Change Order

PROJECT: *(Name and address)*
17003 Southwest Madison Fire
Department
Madison County, Mississippi

CHANGE ORDER INFORMATION:
Change Order Number: 001

Work Changes Proposal Request

Subject: Site Investigation of Unstable Soils

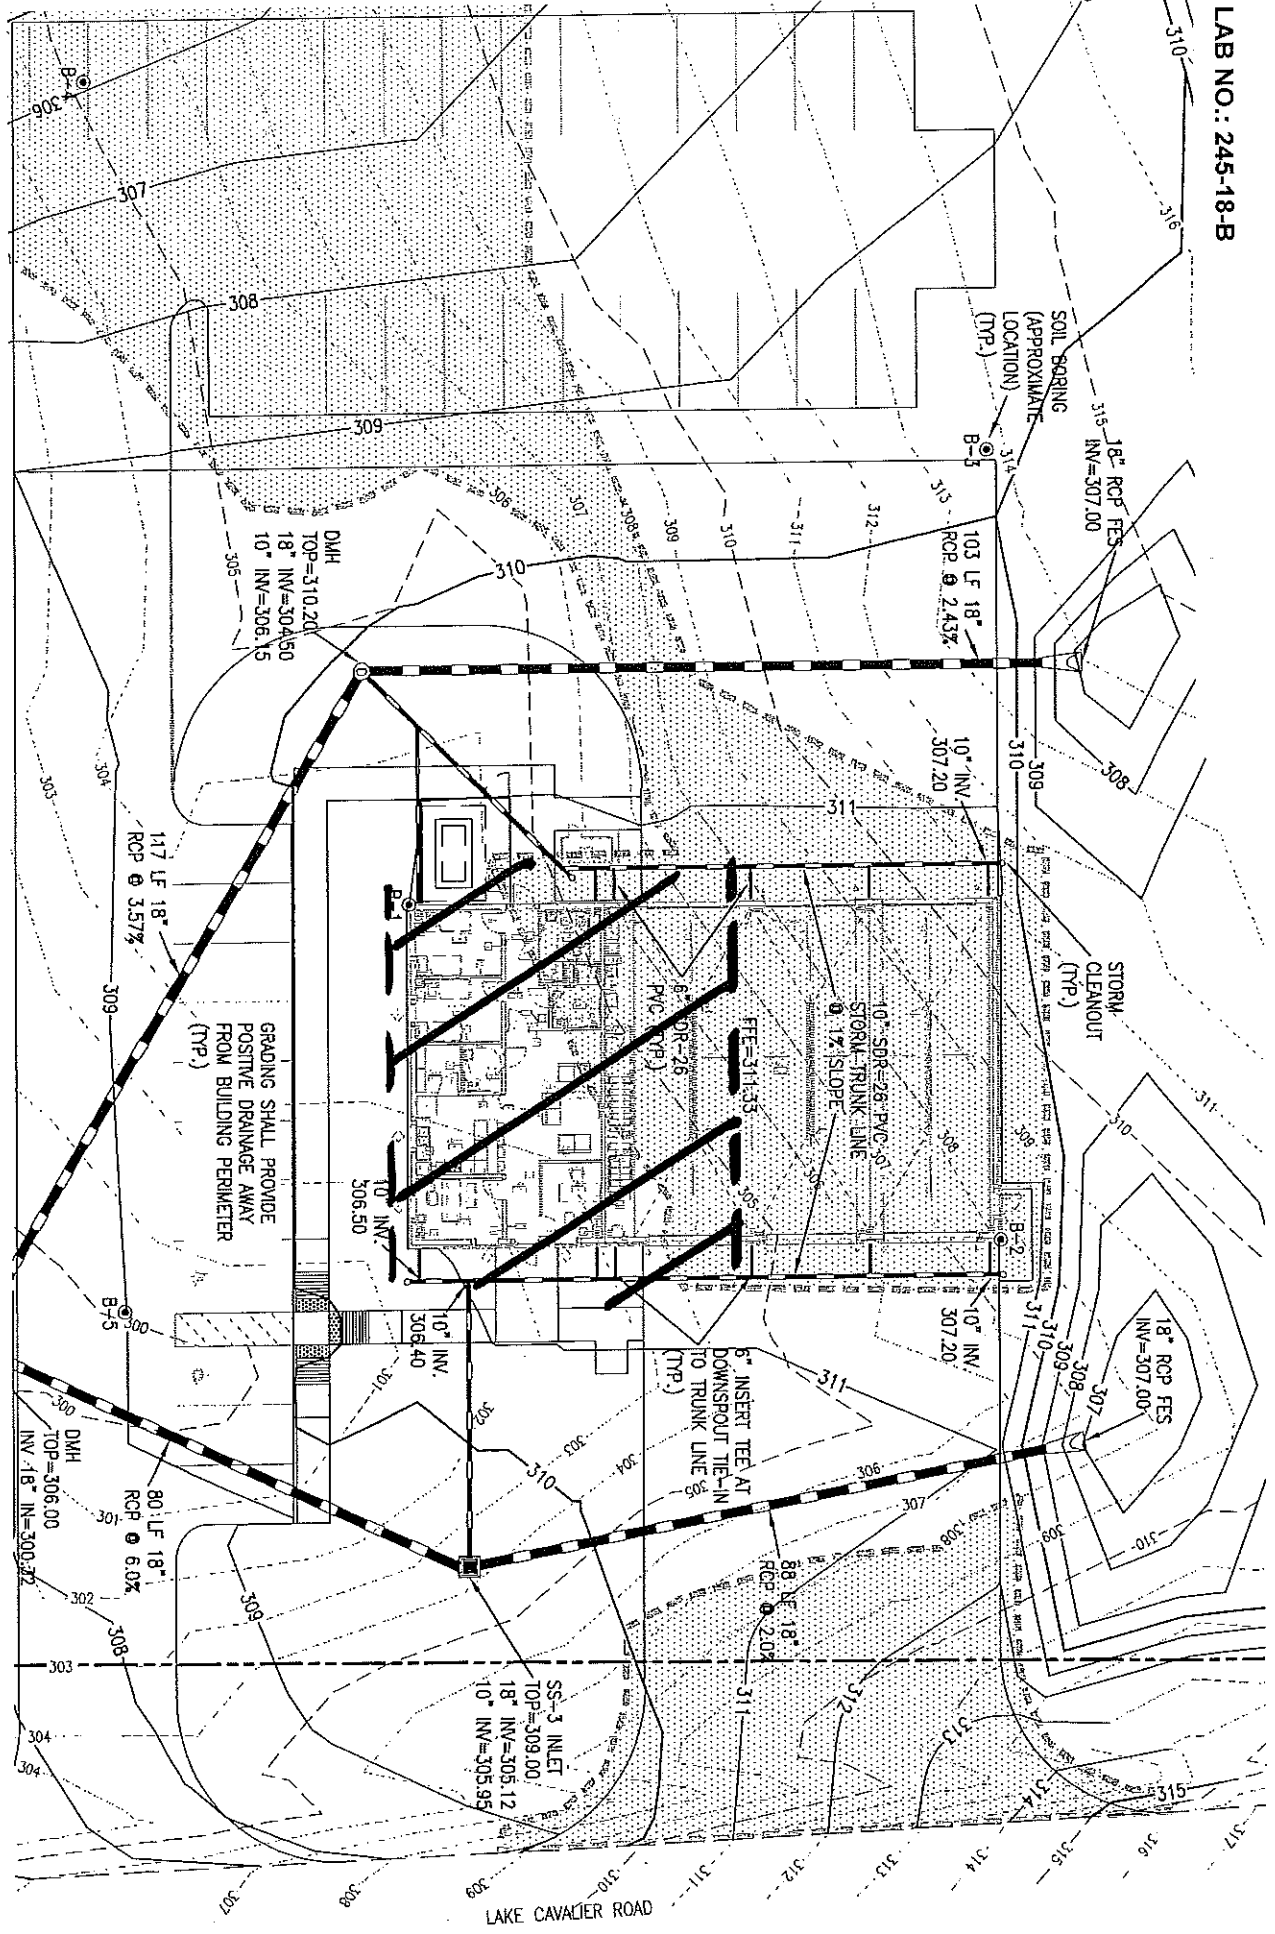
An attempt to proof roll the site with an “unloaded” dump truck was unsuccessful with major rutting and pumping in the lower half of the building area.

Four (4) test holes were excavated in the lower half of the building undercut area. The test holes were excavated to varied depths of 18” to 3 ½ feet to a firm subgrade. The existing material is weak and wet and could consolidate under the weight of the seven (7) feet of compacted fill and new structures.

The area of wet unstable soil should be removed to an average depth of three (3) feet and replaced with compacted select fill.
